**STATE OF TENNESSEE  
DEPARTMENT OF TRANSPORTATION**

**INSTRUCTIONAL BULLETIN NO. 22-03**

**Regarding Various Revised and New Standard Drawings**

**Effective August 19, 2022 letting (June 8, 2022 Turn-in)**, the following Standard Drawings have been revised or are new. In addition, Chapter 10 of the Roadway Design Guidelines - Index of Standard Drawings and the web site have been updated accordingly and are available online.

STANDARD PRECAST  
48" CIRCULAR NO. 25  
CATCH BASIN  
(FOR USE WITH 6" SLOPING CURB)

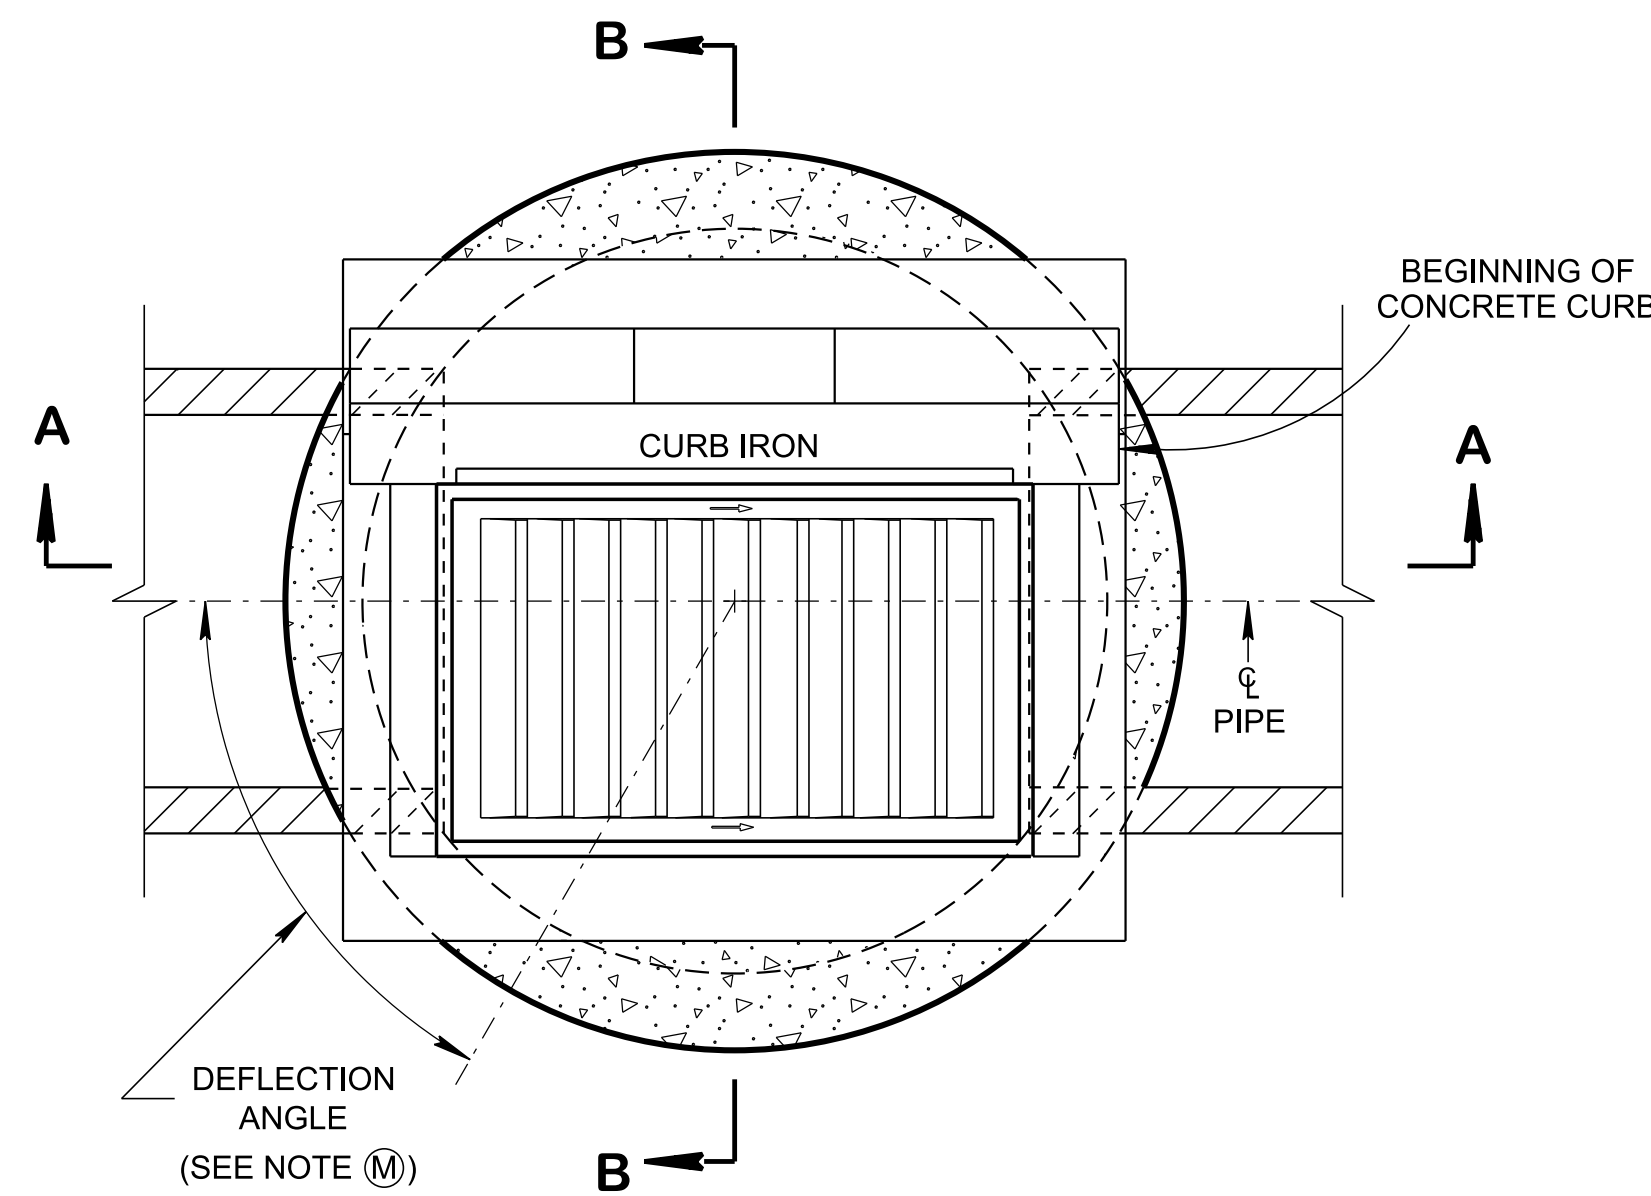
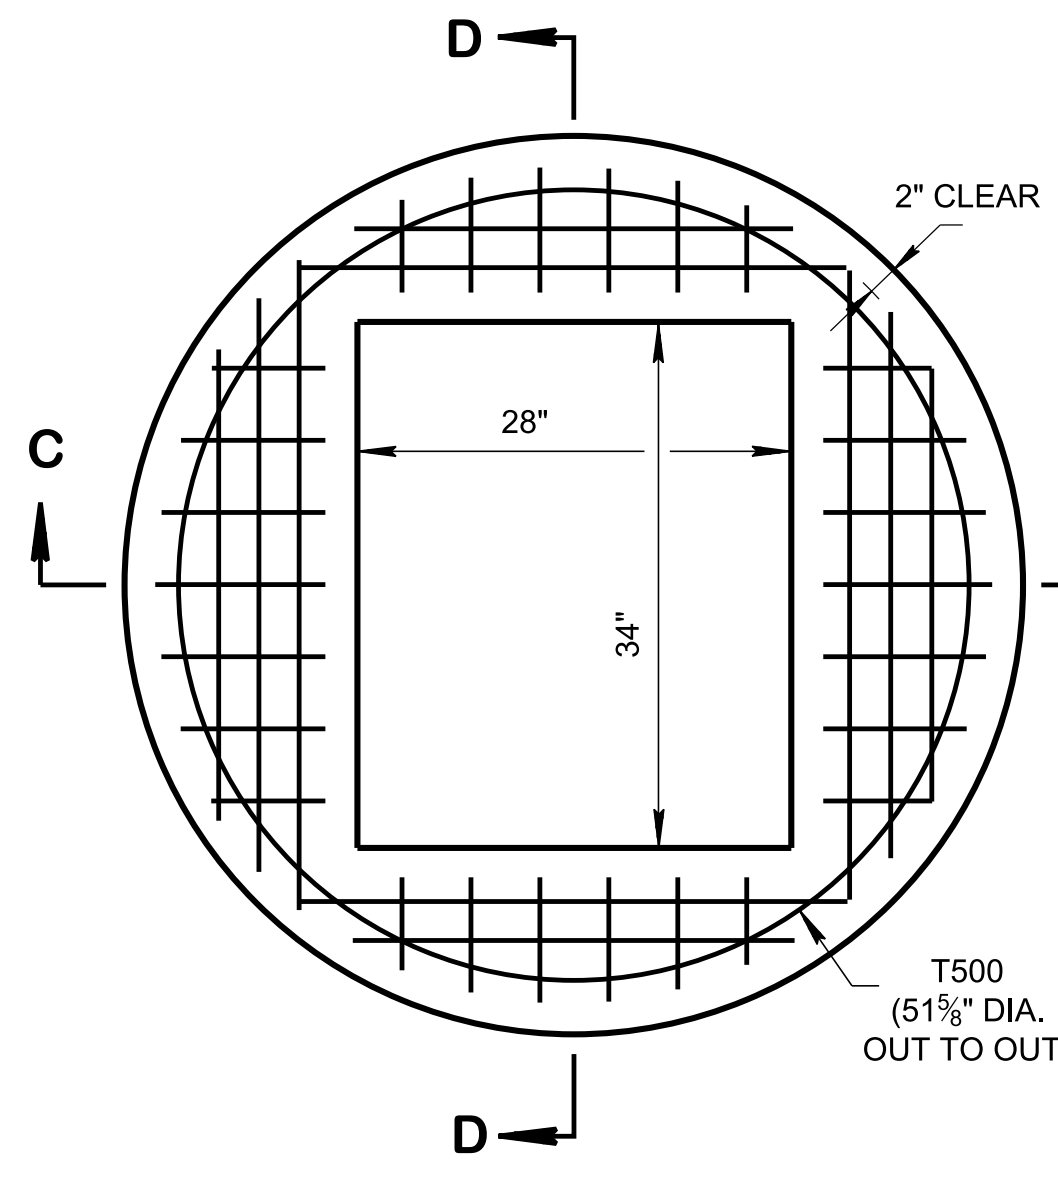
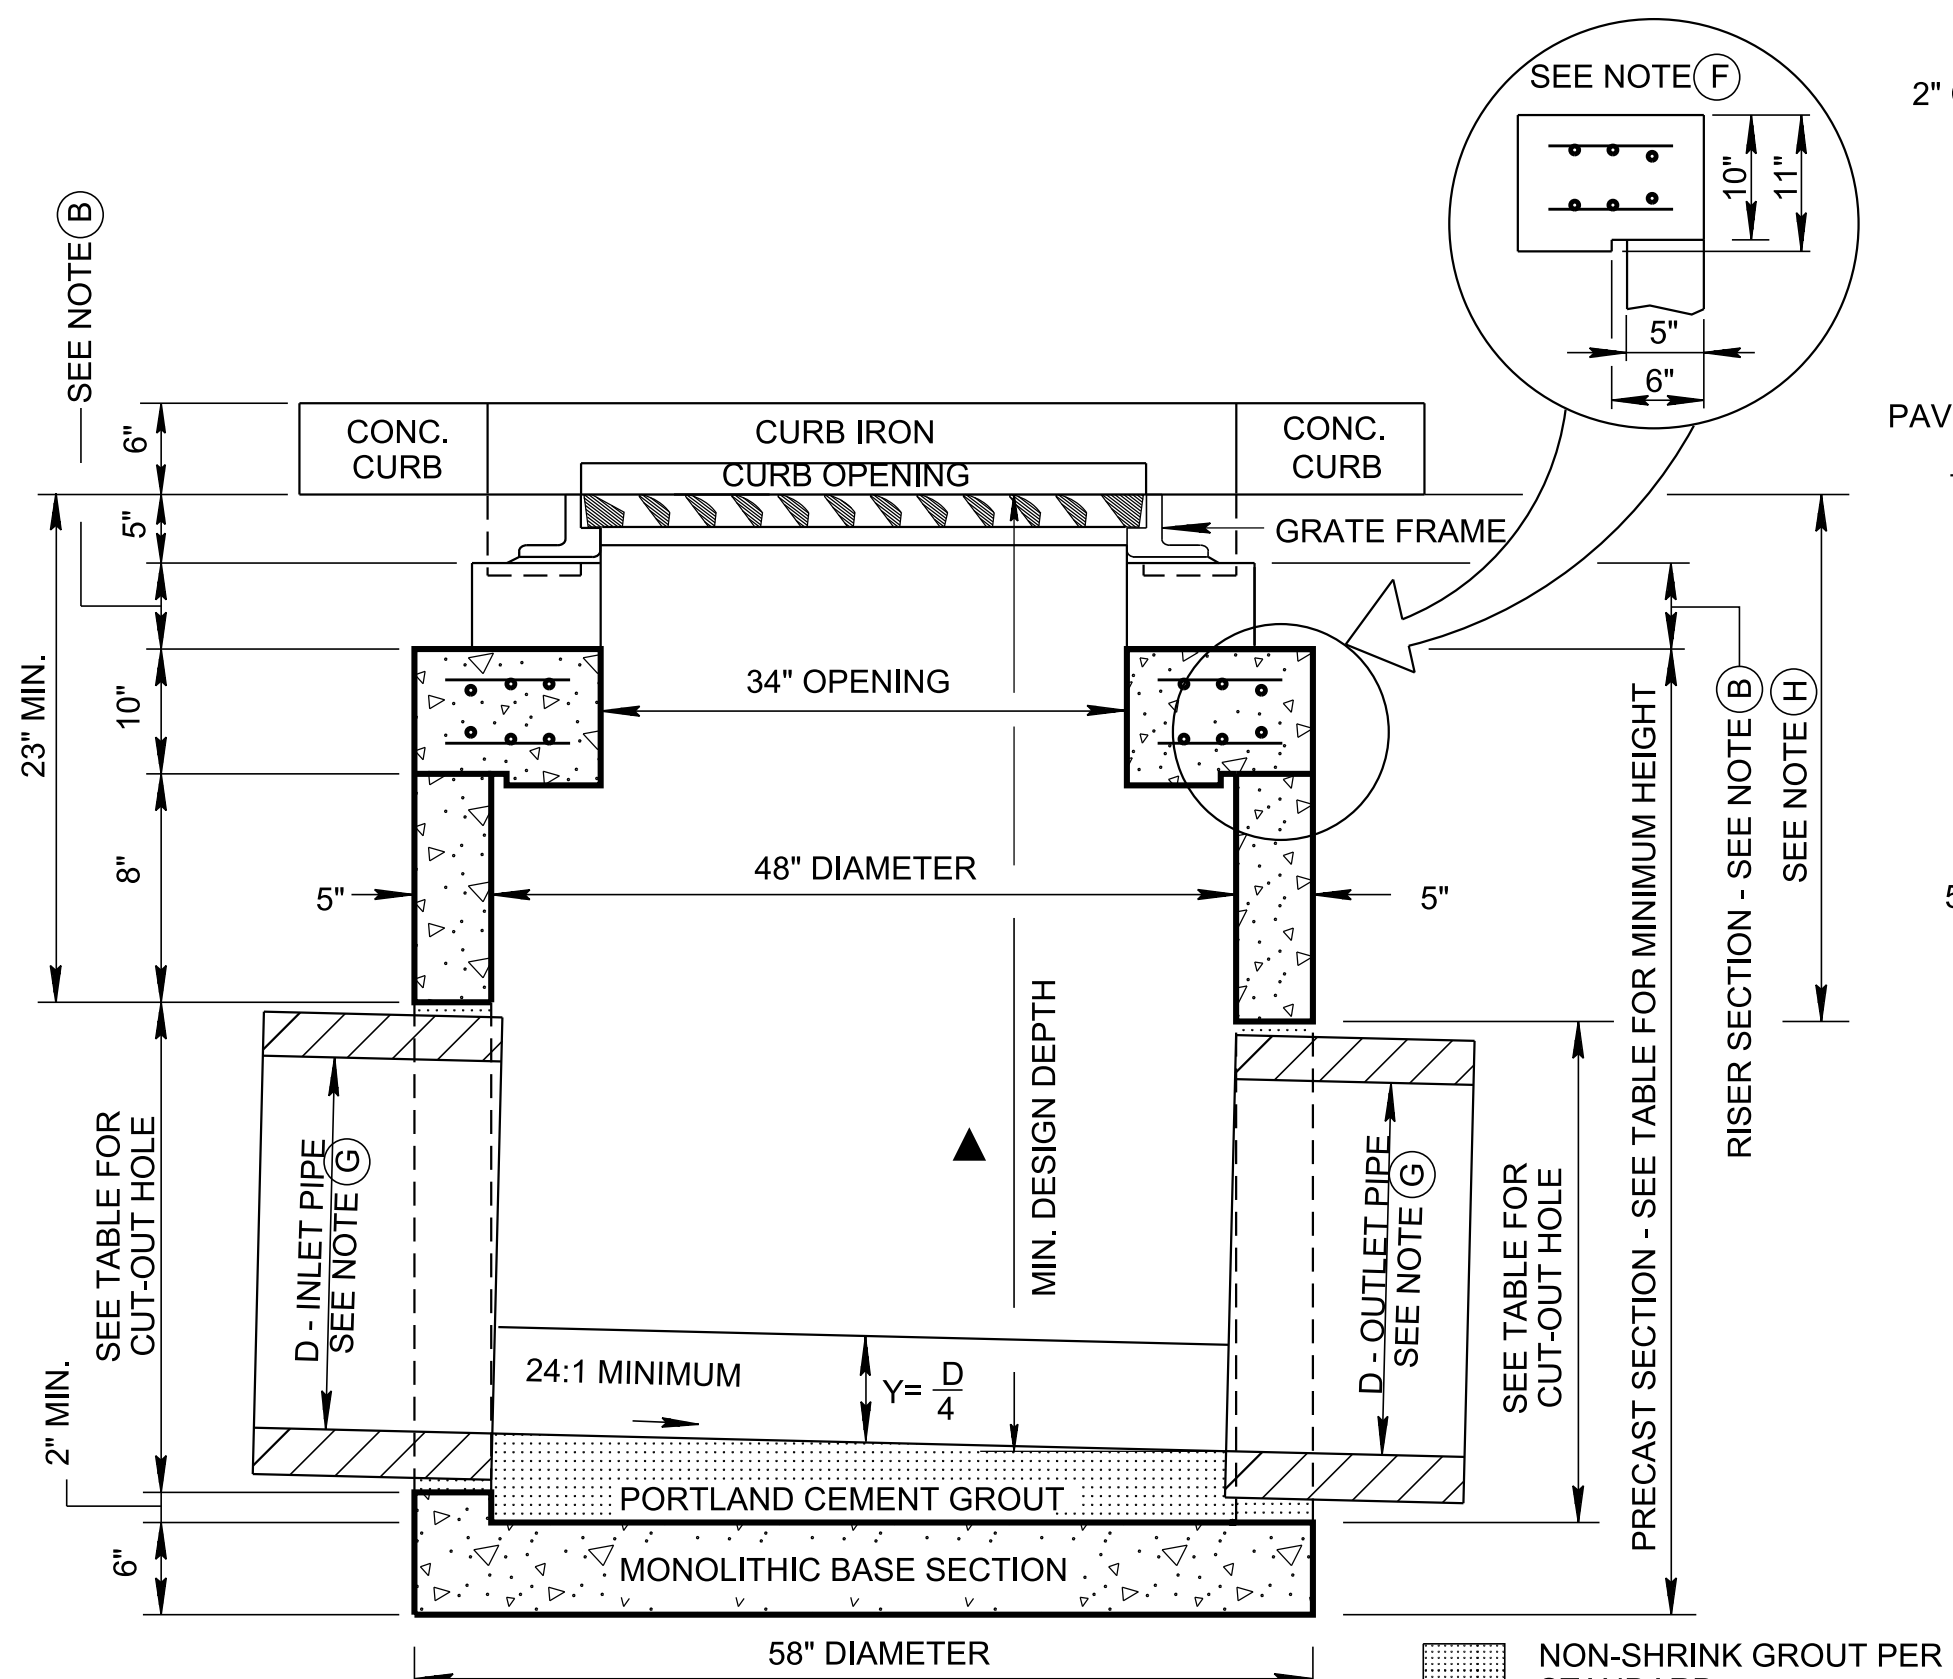
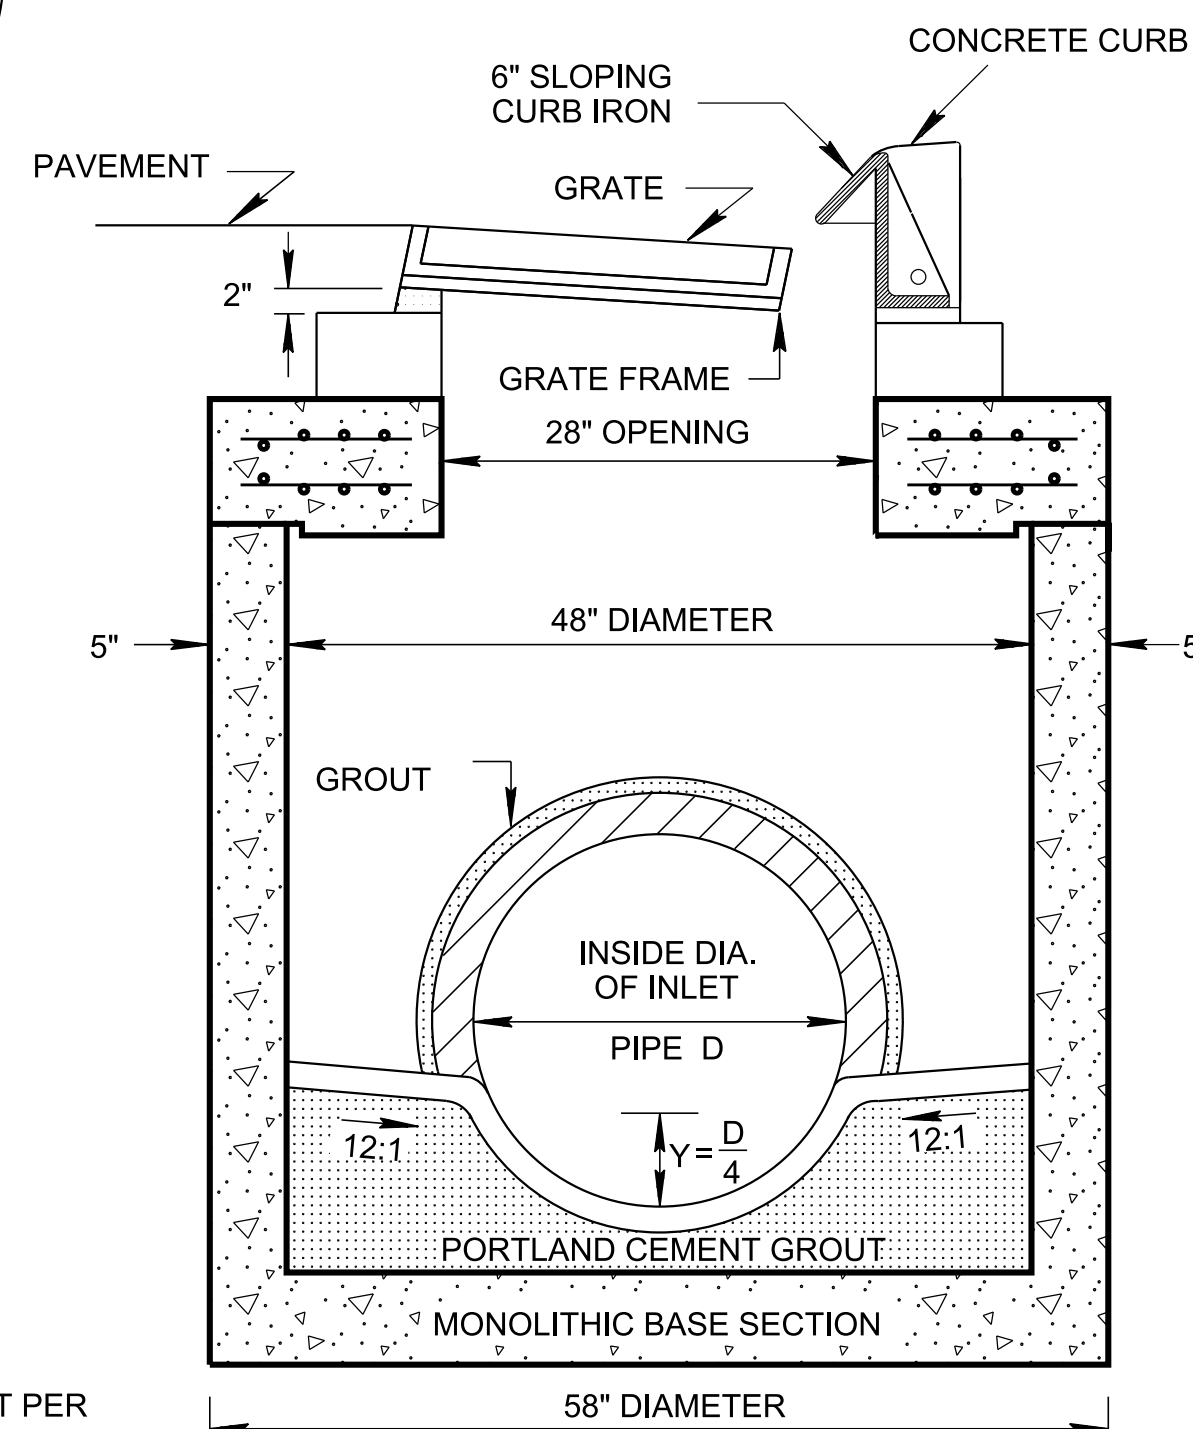
REV. 01-28-2022: DEFLECTION ANGLE NOTE ON PLAN VIEW, AND GENERAL NOTES (L) AND (M) WERE ADDED.

- (L) SEE STANDARD DRAWING D-CB-99RA FOR BILL OF STEEL FOR CATCH BASIN LIDS.
- (M) CONNECTION OF 24" PIPES WILL BE LIMITED TO 60 DEGREE DEFLECTION ANGLE.
